From: Head, Scott [<mailto:smhead@STPEGS.COM>]
Sent: Tuesday, February 22, 2011 2:57 PM
To: Tai, Tom; Tonacci, Mark; Wunder, George
Subject: Paper for SSI Sensitivity Studies for Cracked Concrete and Soil Separation Cases

SSI Analysis Sensitivity Studies for Cracked Concrete and Soil Separation Cases

Comparison of GMRs with the Input Spectrum (Horizontal)

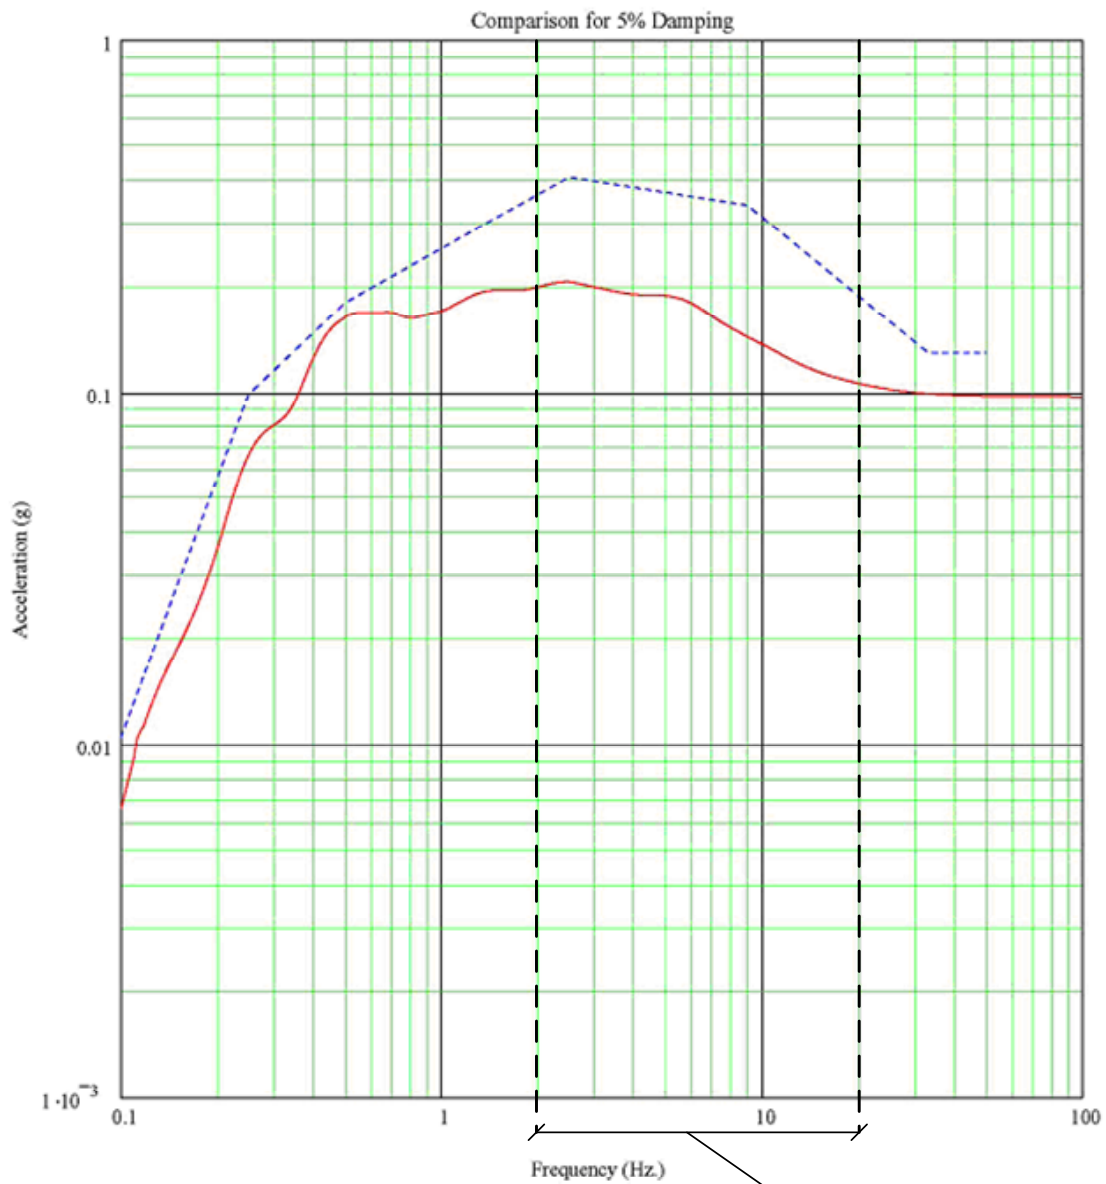
The NRC Staff has requested additional justification for not analyzing the soil separation, cracked concrete and empty fuel tank for the Lower Bound and Mean soil cases, in addition to the sensitivity studies that were done for the Upper Bound soil case. NINA believes that the sensitivity studies for the Upper Bound case are adequate to accomplish the purpose of these sensitivity studies.

- The sensitivity analyses for the STP 3&4 Diesel Generator Fuel Oil Storage Vault (DGFOSV) and the Diesel Generator Fuel Oil Tunnel (DGFOT) also were done for only one soil profile, i.e. the Upper Bound soil case. The NRC Staff has now asked for further justification for not also running the cracked concrete and soil separation analyses for the Lower Bound and Mean soil properties.

1. The attached figure shows that the site-specific SSE response spectrum which we are using for plant design has significant margin over the GMRS in the frequency range of interest to our design. In the figure, the horizontal GMRS that SRP 3.7.2 requires to be considered in the seismic analysis for determination of the plant design loads is represented by the lower curve. However, the site-specific Category I structures, including the Diesel Generator Fuel Oil Storage Vault and the Diesel Generator Fuel Oil Tunnel, were conservatively designed for horizontal accelerations represented by the Input Spectrum, which is the upper curve of the figure. As such, seismic loading used to design the plant is based on accelerations that are essentially double the regulatory requirements in the predominant frequency range of interest.
